Access Compliance Report

Public Rights-of-Way

Intersection ID: 15477	Main Street: W_TYVOLA_RD	Cross Street: CASCADE_POINTE_BV	Location:	N
ADA ID: 0F72234F37B2	Ramp Type: Perp	Initial Pass/Fail: Fail	Overall Compliance: No	Severity Score: 22.5

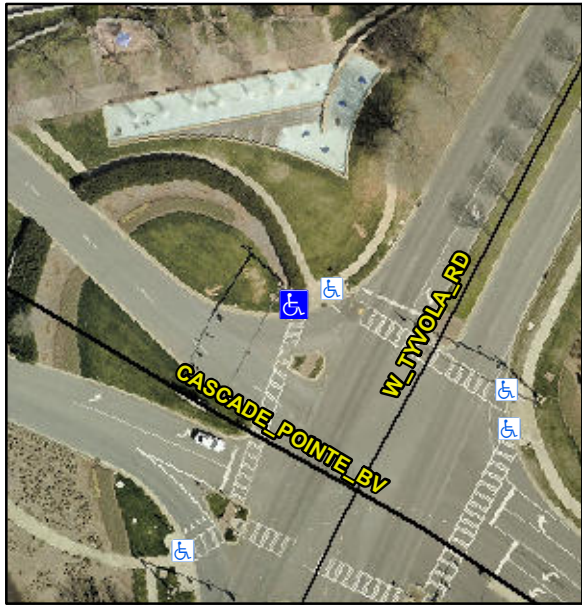
Codes/Mitigation Info/Possible Solution			Field Measurements/Component Compliance					
	Possible Solutions:		Remove & Replace Entire Ramp.					
	Surveyor Notes:		N/A					
	PROW/ADA:		Not Found, R304.5.1, R304.2.2, R304.5.3					
	Street 1 Name		CASCADE POINTE BV					
	Stop Condition-Street 2		Signal					
	Street 2 Name		N/A					
	Stop Condition-Street 1		N/A					
	Total Cost:		\$ 1850.00					
			Compliance	Description	Data	Compliance	Description	Data
			N/A	Ramp Length (in)	78.0	No	Ramp Slope (%)	10.0
			No	Ramp Width (in)	42.0	No	Ramp XSlope (%)	3.2
			N/A	Flare Type LT	N/A	N/A	Flare Type RT	N/A
			N/A	Flare Slope LT (%)	N/A	N/A	Flare Slope RT (%)	N/A
			N/A	Flare Traversable LT?	N/A	N/A	Flare Traversable RT?	N/A
			N/A	Landing Length (in)	N/A	N/A	DWS Provided?	N/A
			N/A	Landing Width (in)	N/A	N/A	DWS Contrast?	N/A
			N/A	Landing Slope (%)	N/A	N/A	DWS Length (in)	N/A
			N/A	Landing X Slope (%)	N/A	N/A	DWS Full Width?	N/A
